Access Compliance Report Public Rights-of-Way (RR Crossings)

Intersection ID: 51491	Main Street: N_TRYON_ST	Location: N/A
ADA ID: 0EDE5808A145	Overall Compliance: No	Severity Score: 0.0
Codes/Mitigation Info/Possible Solution		Field Measurements/Component Compliance

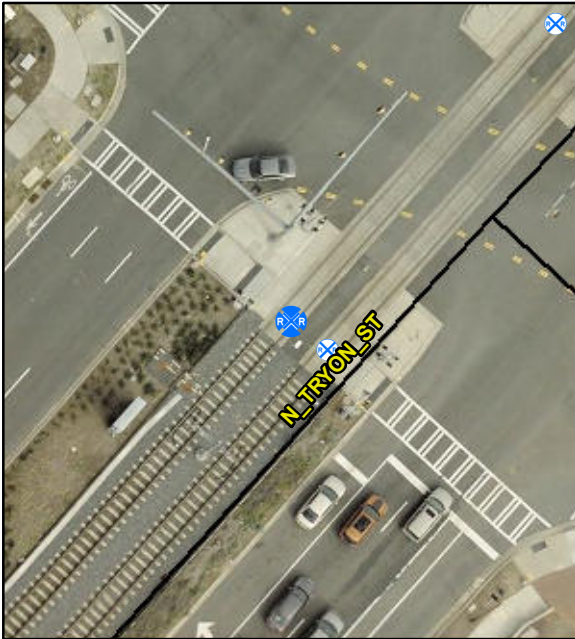
**Remove & Replace Walking Surface
Adjacent to Rail.**

R302.7.4

Compliance	Description	Data
Yes	DWS Provided?	Yes
Yes	DWS Contrast?	Yes
Yes	DWS Width (in)	Yes
Yes	DWS Length (in)	24.0
Yes	DWS Offset (in)	159.0
Yes	Pedestrian Gate?	Yes
N/A	DWS Outside Gate?	Yes
N/A	Rail Type?	LightRail
No	Flangeway Gap (in)	3.0
Yes	Sidewalk Width (in)	119.0
